## Access Compliance Report Public Rights-of-Way (Curb Ramps)

Intersection ID: 10041624 Main Street: WHITEHALL\_EXECUTIVE\_CENTERS SDStreet: N/A Location: SE

ADA ID: 2194DE596211 Ramp Type: Perp Initial Pass/Fail: Fail Overall Compliance: No Severity Score: 18.75

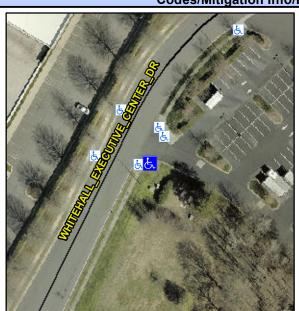
Not Found, R304.5.1, R304.5.3

Field Measure	ments/C	<u>ompo</u>	nent Compliance	
Compliance Description		Data	Comp	Compliance Description	
N/A	Ramp Length (in)	96.0	Yes	Ramp Slope (%)	6.8
No	Ramp Width (in)	33.0	No	Ramp XSlope (%)	2.2
N/A	Flare Type LT	N/A	N/A	Flare Type RT	N/A
N/A	Flare Slope LT (%)	N/A	N/A	Flare Slope RT (%)	N/A
N/A	Flare Traversable LT?	N/A	N/A	Flare Traversable RT?	N/A
N/A	Landing Length (in)	N/A	N/A	DWS Provided?	N/A
N/A	Landing Width (in)	N/A	N/A	DWS Contrast?	N/A
N/A	Landing Slope (%)	N/A	N/A	DWS Length (in)	N/A
N/A	Landing X Slope (%)	N/A	N/A	DWS Full Width?	N/A
N/A	Landing Curb? (Y/N)	N/A	N/A	DWS Offset (in)	N/A
N/A	Shared Landing?	N/A			
N/A	Gutter Ponding?	N/A	N/A	Gutter Slope (%)	N/A
N/A	Gutter Lip Ht (in)	N/A	N/A	Gutter X Slope (%)	N/A
N/A	Painted X Walk1?	No	N/A	Painted X Walk2?	N/A
	X Walk 1 Direction	To N		X Walk 2 Direction	N/A
N/A	X Walk 1 Width (in)	N/A	N/A	X Walk 2 Width (in)	N/A
	X Walk 1 Slope (%)	6.2		X Walk 2 Slope (%)	N/A

Remove & Replace Entire Ramp.
